**BEFORE A COMMISSIONER PANEL APPOINTED BY CHRISTCHURCH
CITY COUNCIL AND CANTERBURY REGIONAL COUNCIL**

In the matter of an application by Christchurch City Council for resource consent to establish and operate a wastewater treatment scheme and associated discharges to land as part of the Akaroa Treated Wastewater Irrigation Scheme at 80 Old Coach Road, Akaroa, 11 Sawmill Road, Duvauchelle, 6583 Christchurch Akaroa Road, Akaroa, and Jubilee Park, Akaroa (RMA/2023/1347, CRC235038, CRC235039, CRC235040 and CRC235041)

**SUBMISSION TO THE ATWIS HEARING PANEL
PRESENTED BY
MS SUKY THOMPSON, DR BRENT MARTIN, JAN COOK
ON BEHALF OF
FRIENDS OF BANKS PENINSULA INCORPORATED**

11 February 2025

Figure 1 Modelled versus Actual Flow Winter 2022²⁰

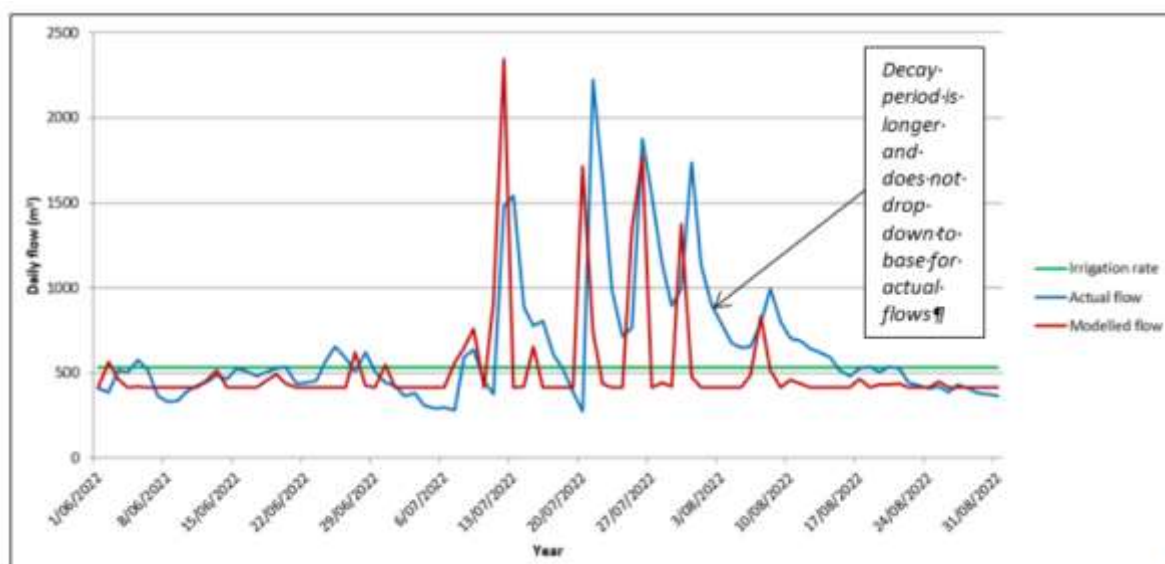
- 3.6.5 Further analysis revealed that the Beca/PDP model, based on dry years, had failed to take into account the long time it takes for the soil to drain during wet winters when the ground is saturated, and therefore groundwater infiltration continues for a prolonged period in wet years compared with dry years. The chart below comparing modelled with actual flows for the wet year of 2022 demonstrates this.

- 3.6.6 He further advised that based on a simpler (but more accurate) regression model of winter rainfall versus storage, 12,000m³ would be inadequate in 22 of the 51 years modelled.

Figure 2 Proposed system

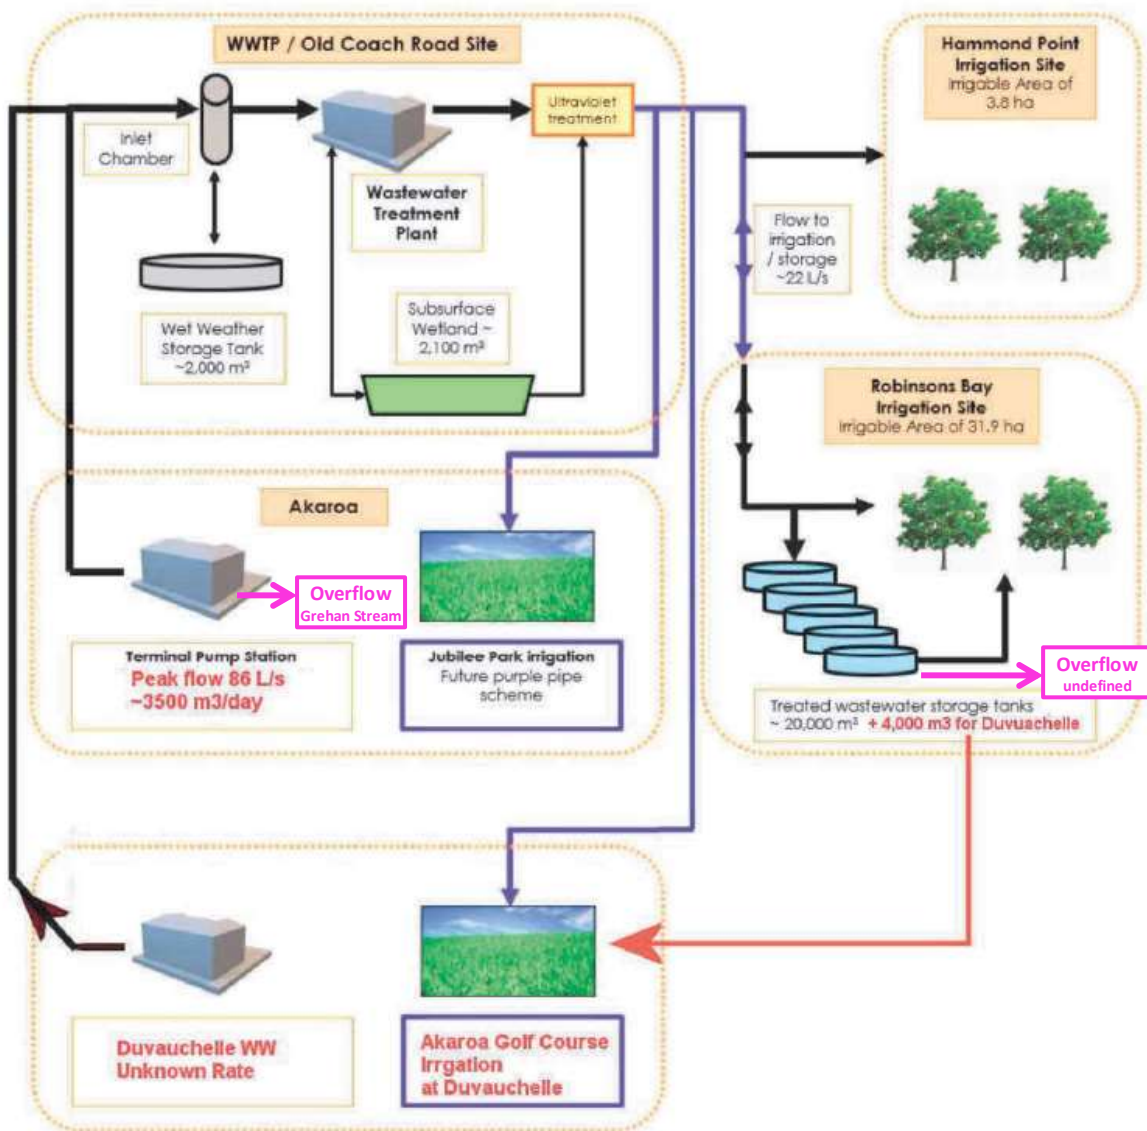
4.1.1 We generally agree with the schematic provided in Figure 2, CI 31 of the CRC s42A report which includes the various updates in red.

4.1.2 However, it omits the overflow paths now identified so we reproduce it below with these added in pink.

Figure 3 Landscape plan showing irrigation areas in pink from Applicants evidence

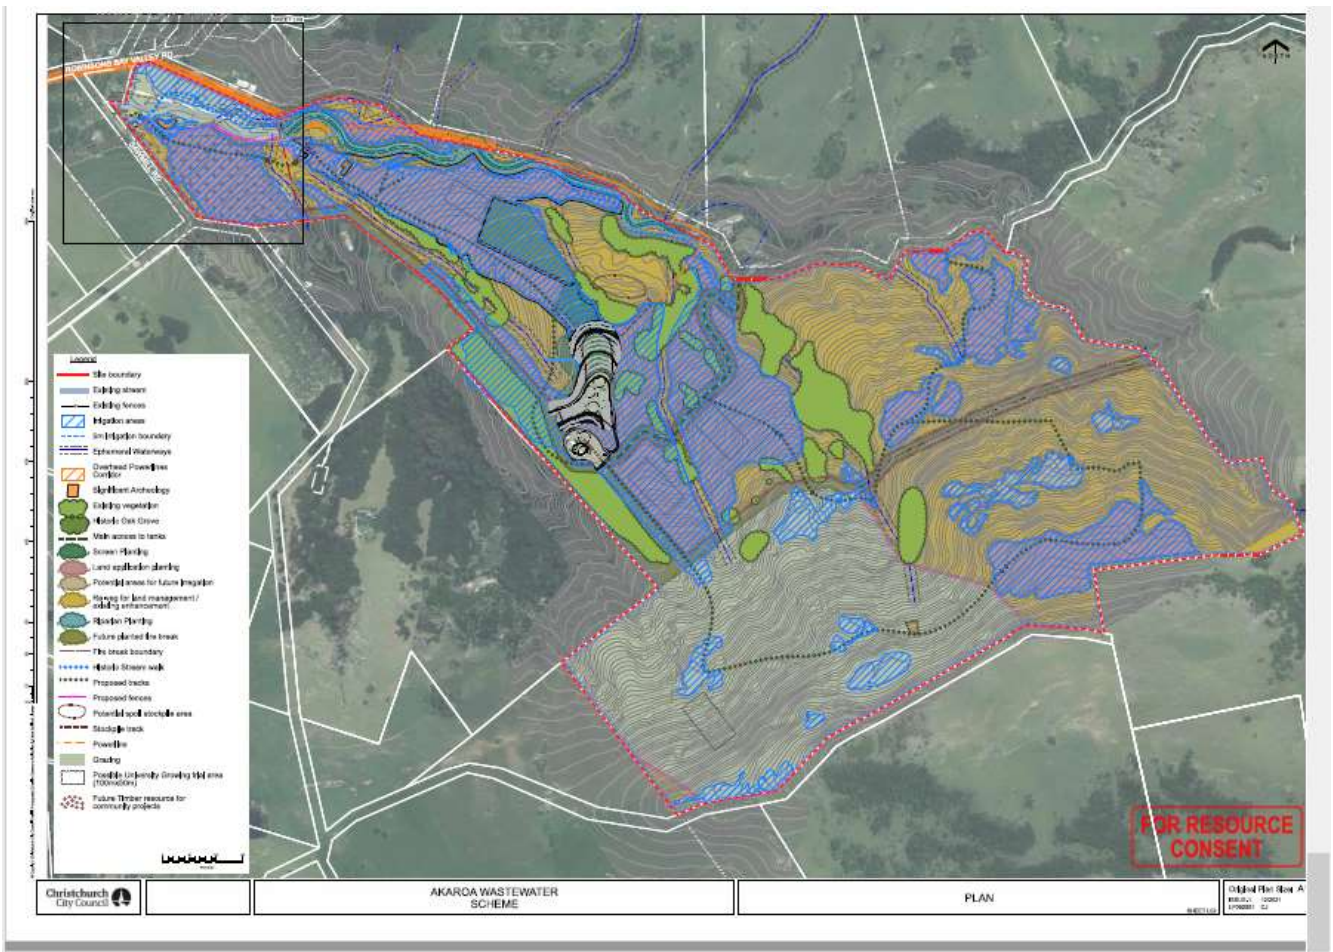
4.9.3 Some clarifications are needed as to what areas now form part of the Application for irrigation,

- a) In response to questions from the Panel, the Applicant clarified that consent is only sought for the areas which are shown in pink crosshatched with blue lines on the landscape map above, and not for any other areas marked as potentially irrigable on various landscape maps, including those areas marked with cross hatched blue lines only, and the shaded areas indicated as “less suitable”. **This statement needs to be re-confirmed and included in any conditions if it is indeed the case, as it directly contradicts other evidence. The Applicant cannot then rely on these areas for expansion of the irrigation field without further consents.**

- b) Also in response to questions, Mr. Woods indicated that the areas immediately around the storage tanks were to be irrigated for the purpose of establishing and maintaining them. The extent of these areas needs to be defined, and they need to be marked appropriately on the map if they do not form part of the disposal irrigation field.

- c) We also note that there are some discrepancies between the areas marked pink on this map as the land application planting, and on the irrigation areas map in Figure 5, Appendix A (Aqualinc Report) of the AEE.

Figure 7 Upper and North-eastern irrigation areas of concern

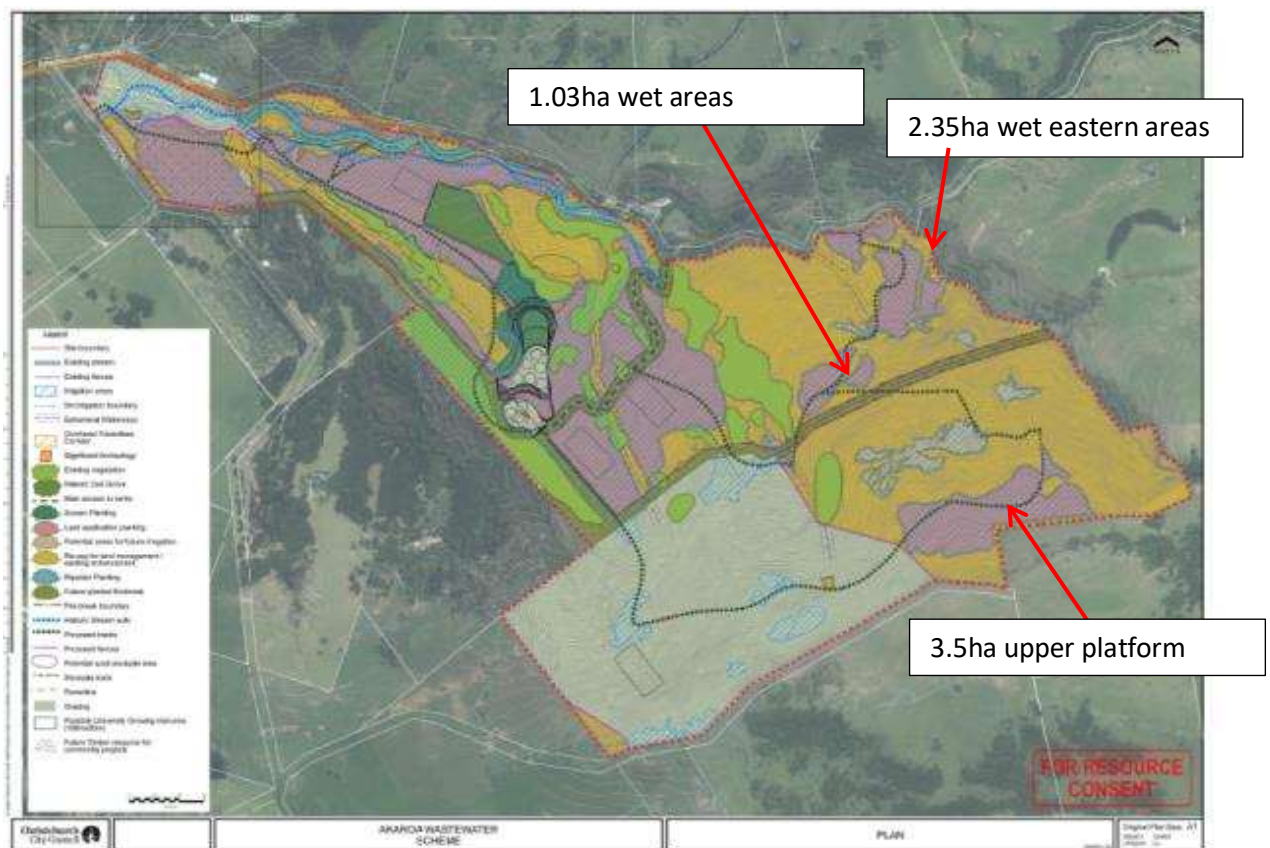
12.4.17 **Scenario 3:** The table below progressively removes areas from the total 35.7ha irrigable area. The areas we removed are those identified in Figure 7 Upper and North-eastern irrigation areas. These are the areas that have not been geotechnically assessed, the original landowner identified them as unsuitable for irrigation, and they were saturated and ponding on our visual inspection in August

Figure 8 Slopes in Irrigation areas

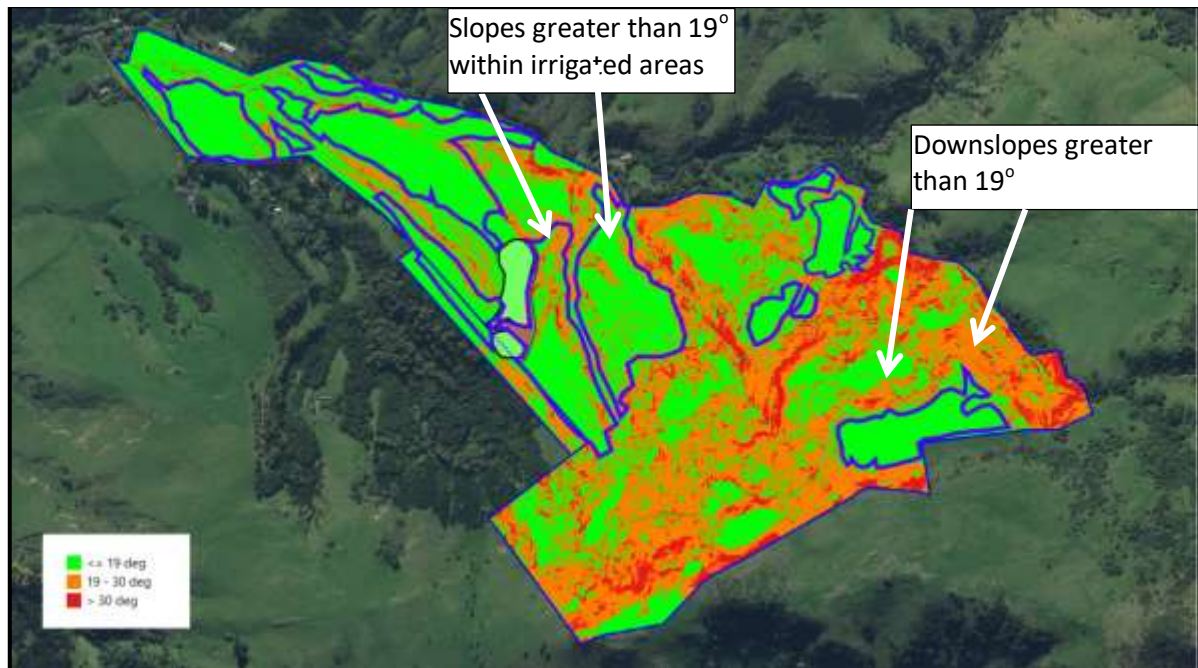
9.3.2 The diagram below shows the irrigation areas outlined in purple with colour coding indicating different categories of land slope:

9.3.3 As can be seen in the map above, the irrigation area immediately to the east of the tank platform contain slopes of greater than 19° as does its neighbour. Several irrigation areas in the upper areas have downslopes exceeding 19° and occasionally greater than 30° .

Figure 9 Tree Trial layout¹²⁵

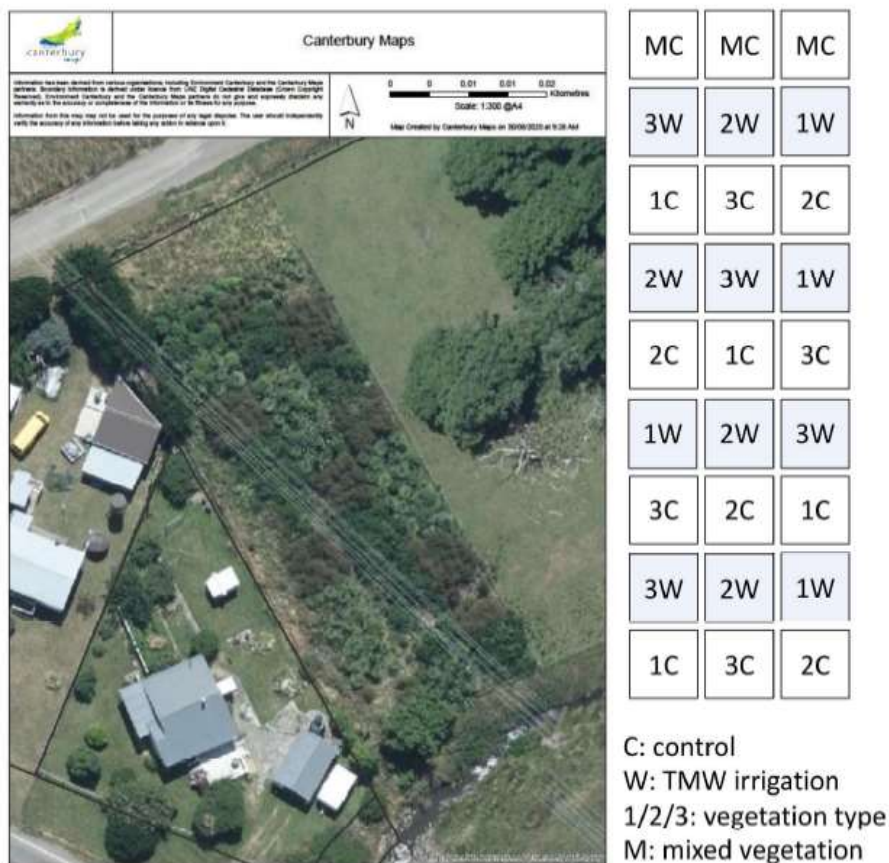
10.3.19 Finally, the tree trial alternated control plantings (which were not irrigated) and irrigated plantings in rows horizontally down the gentle slope as shown below.

Figure 10 Mr McIndoe's soil moisture diagram

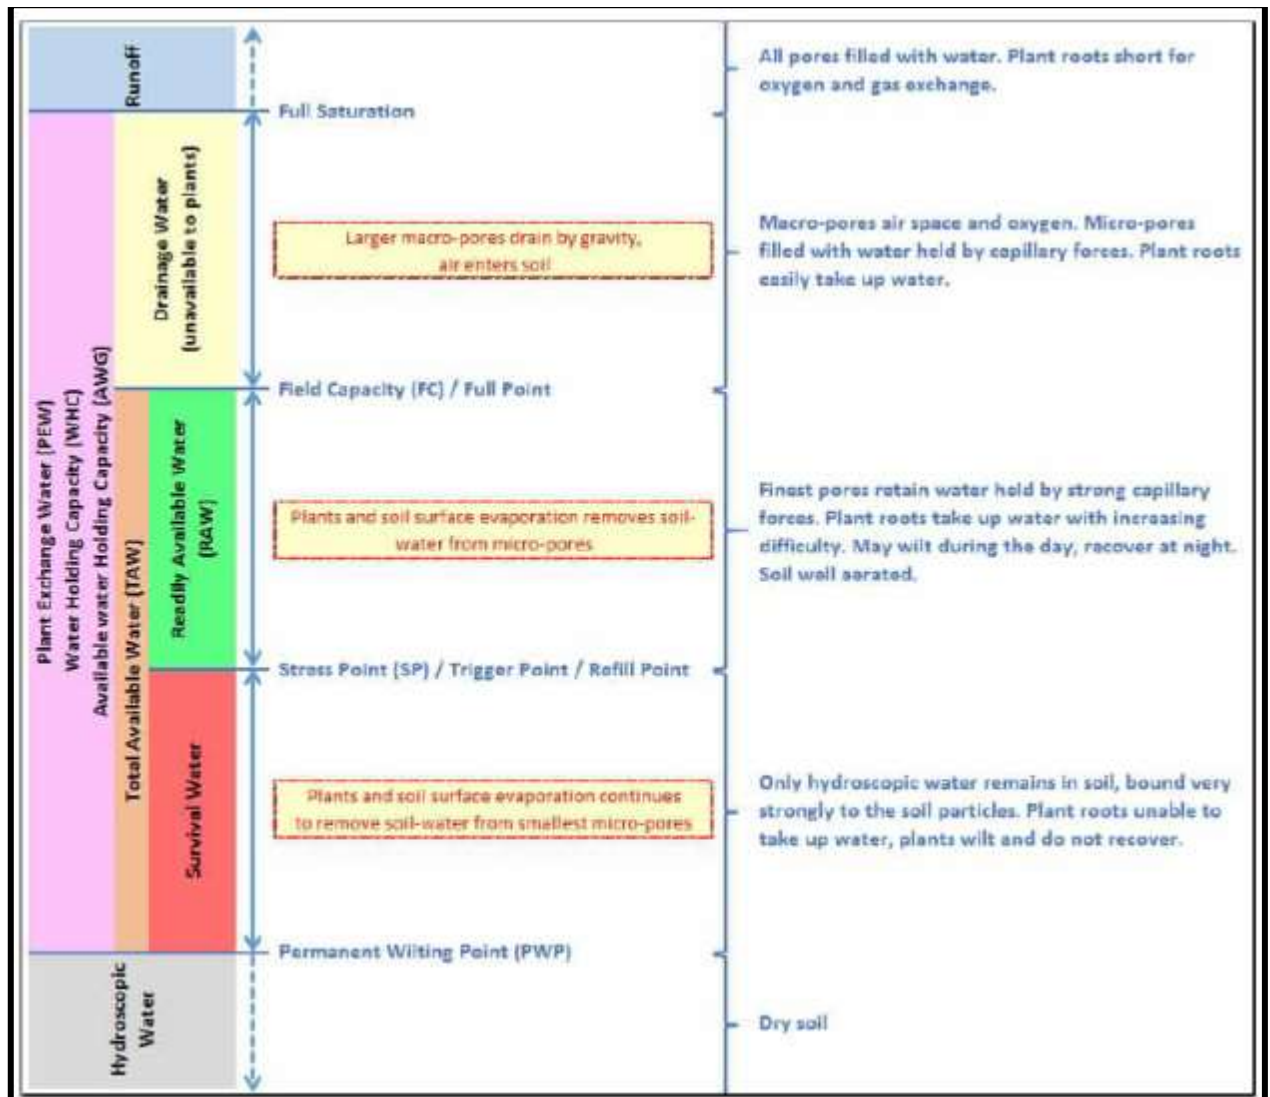
11.1.2 We reproduce below the diagram provided by Mr McIndoe with his Applicant evidence which gives a similar explanation.

11.1.3 The Application proposes to irrigate above field capacity to saturation, and only cease when ponding and runoff are evident. This occurs at full saturation once there is no ability for the soil to drain. There is no prior cut-off proposed when heavy rain is *forecast*, even in already wet conditions.

Figure 12 Example Akaroa Daily flows used as a proxy for soil moisture levels at Robinsons Bay

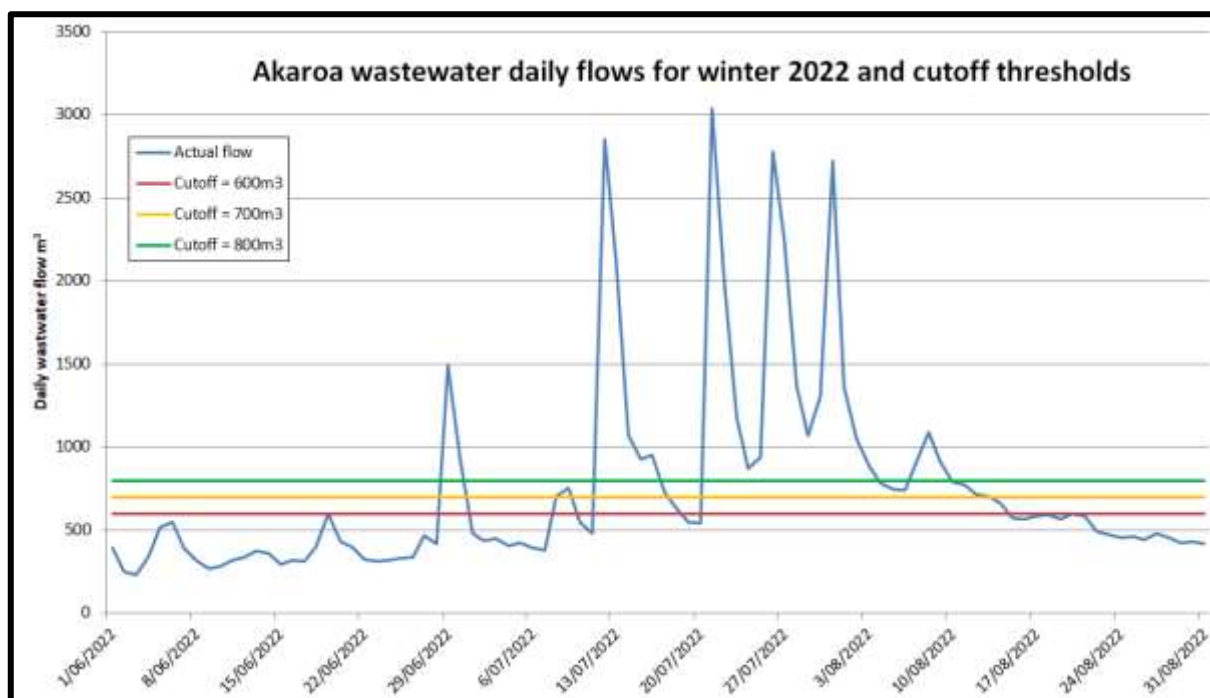
12.4.14 The chart below shows the Akaroa wastewater daily flows for the winter in example year 2022. As can be seen, during dry weather flow levels are below 500m³ per day. The three cut-off levels we have chosen to model are marked with horizontal lines, and are 600 m³, 700 m³ and 800 m³

respectively. At these levels flows are all part of large peaks, indicating high levels of I&I due to both rain and drainage from Akaroa soils.

12.4.15 In the table below we have used 3 different inflow levels as the cut-off to stop and start irrigation, which are significantly above typical winter dry weather flows of around 450m³.

Figure 15 Heritage Area 11 Sawmill Road Robinsons Bay

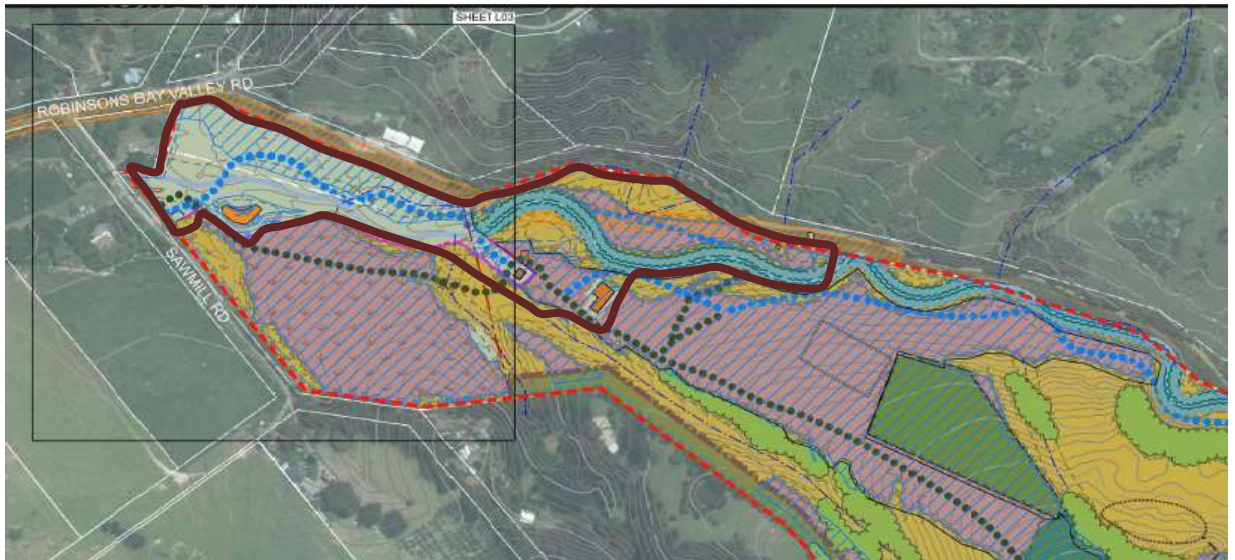
- 22.8.1 The heritage area (as set out on the map in Figure 15) is to be fenced and managed for its archaeological, heritage values and amenity values, and will not be planted for irrigation, irrigated, or used for irrigation related construction. Grazing will be light and only with sheep. Willow windrows are to be removed.
- 22.8.2 The current site access at the Sawmill site is to be removed and returned to a grass track and restricted to use by light vehicles in dry weather only
